LiDAR Quality Assessment Report

Project ID:
GSL_BearRiver_UT

Project Description:
This project encompasses five areas in five Utah counties and encompasses about 1147 square miles shown below. Data was collected on September and October, 2011.

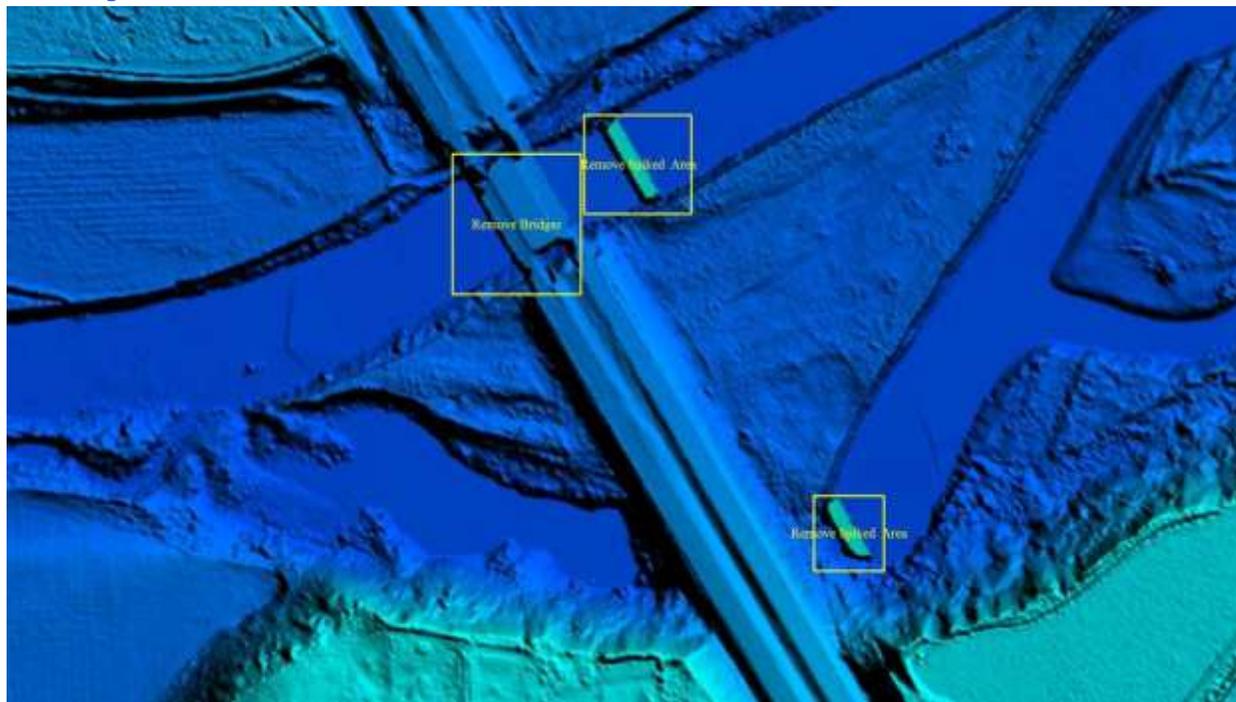
Remove Bridges & Spiked Areas

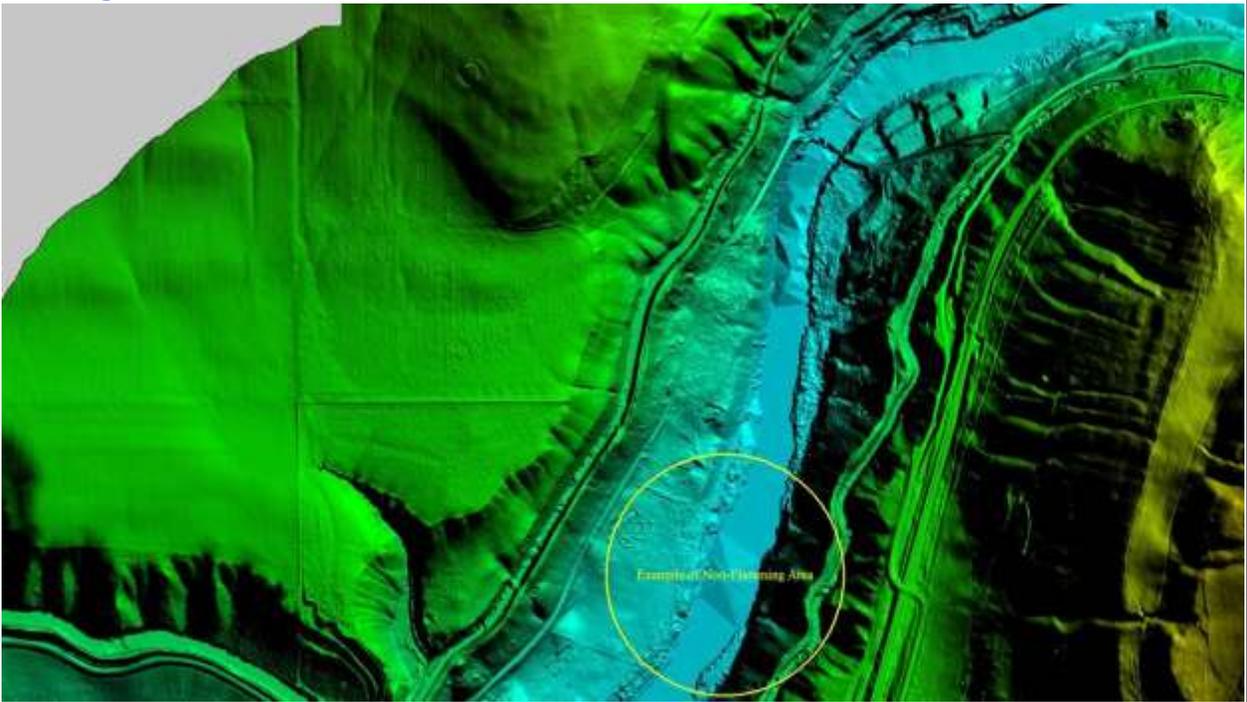
Flatten Water Area
